Japan Positions for Battery Durability GTR @EVE50

21. June.2021

Japan Positions on Open Issues

Proposed Flow Chart

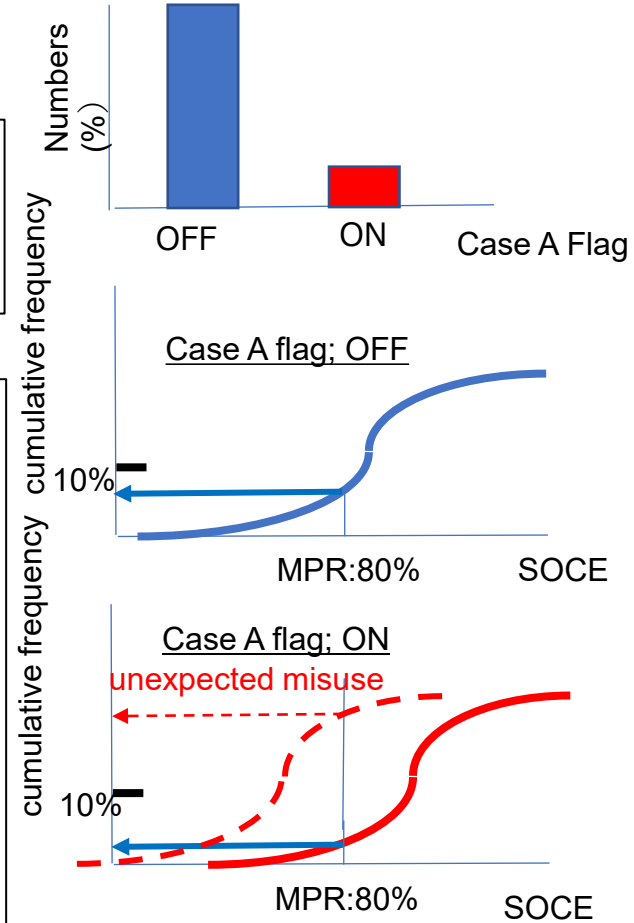
***1** : supports originally agreed within IWG

***2** : OK to remove with applying the virtual mileage concept

***3** : exclude Case A flag ON vehicle from sample but require additional information data

***4** : supports the proposal by EC
